Service Bulletin

SB 81439-XX-00-14

2101 Approach GPS Navigation Systems, Part Numbers 81439-00-XXXX, 81439-01-XXXX, 81439-10-XXXX and 81439-11-XXXX.

Release of operating system -242M.

Figure 1
Disassembly of Housing

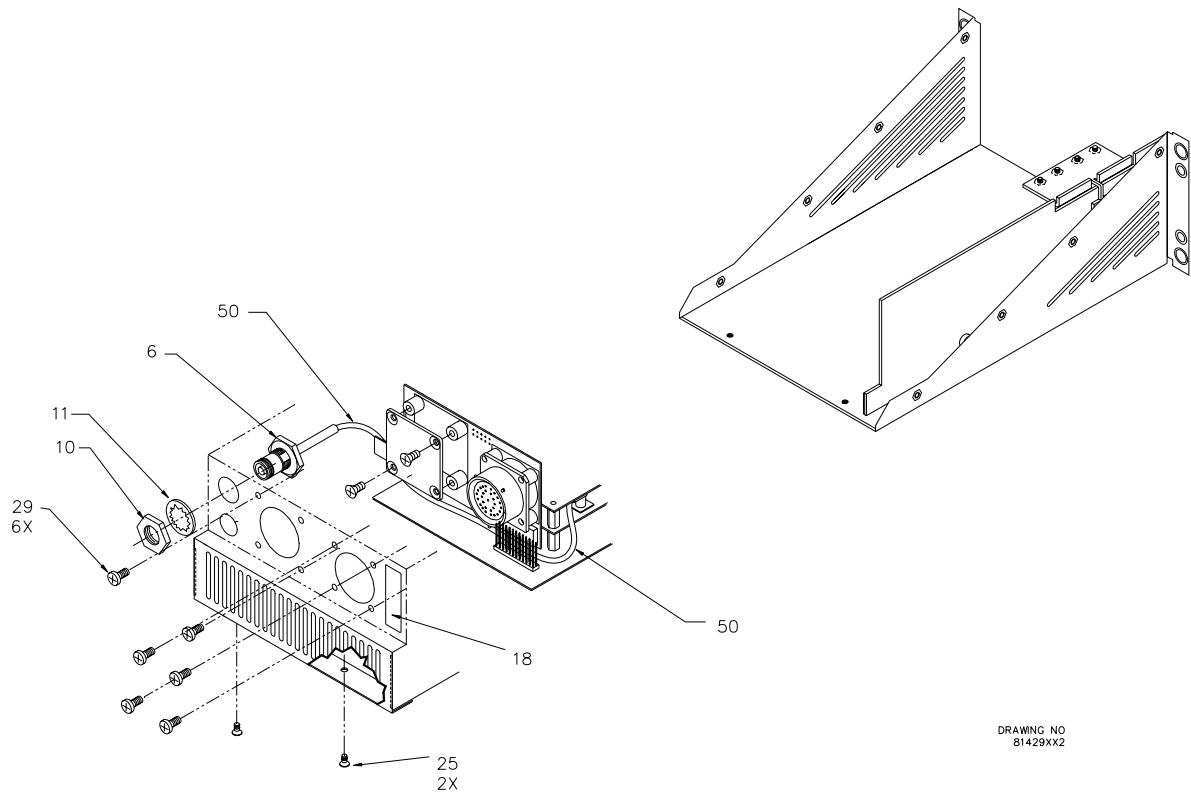
When the unit has passed Checkout satisfactorily, refer to Figure 1 and replace the old Identification Label with the supplied Identification Label (Item 17) in the middle of the top cover.

Figure 4
Processor CCA
Detail Showing Location of EPROMs

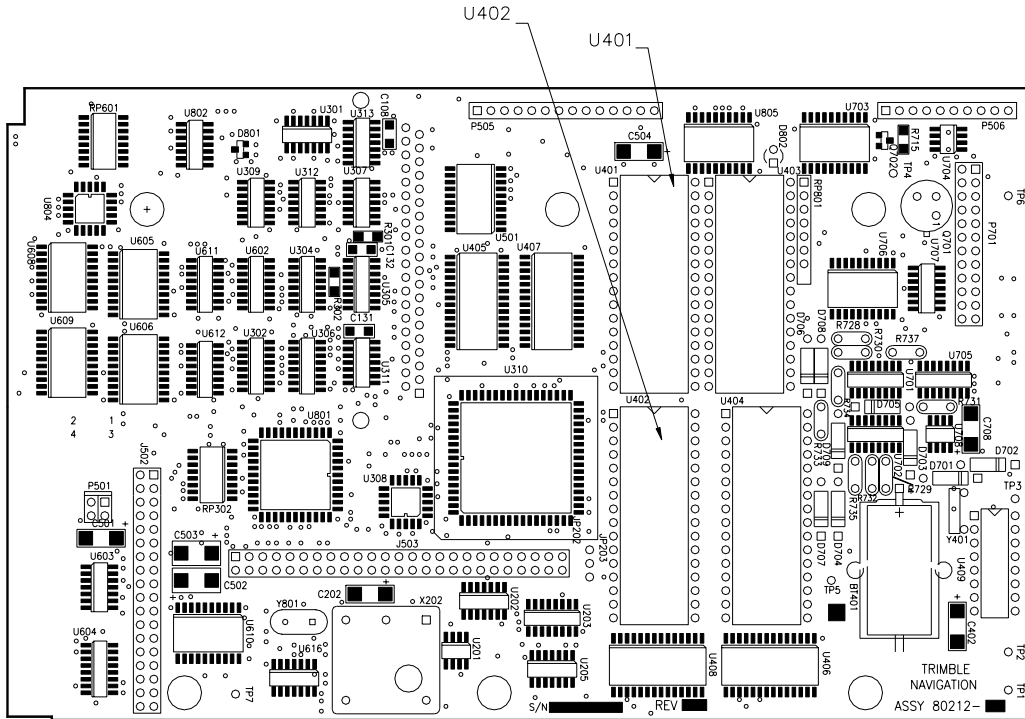
Refer to figures 3 and 4.

The following instructions apply to the top of the Processor CCA (Item 107).

1. Locate EPROMs (U401 and U402) on the Processor CCA.
2. With a chip-pulling tool, remove the EPROMs U401 and U402.
3. Install supplied EPROMs, PN 80418-242M, into the U401 and U402 sockets on the Processor CCA. Install EPROMs with notch in same orientation as the notch on the socket.
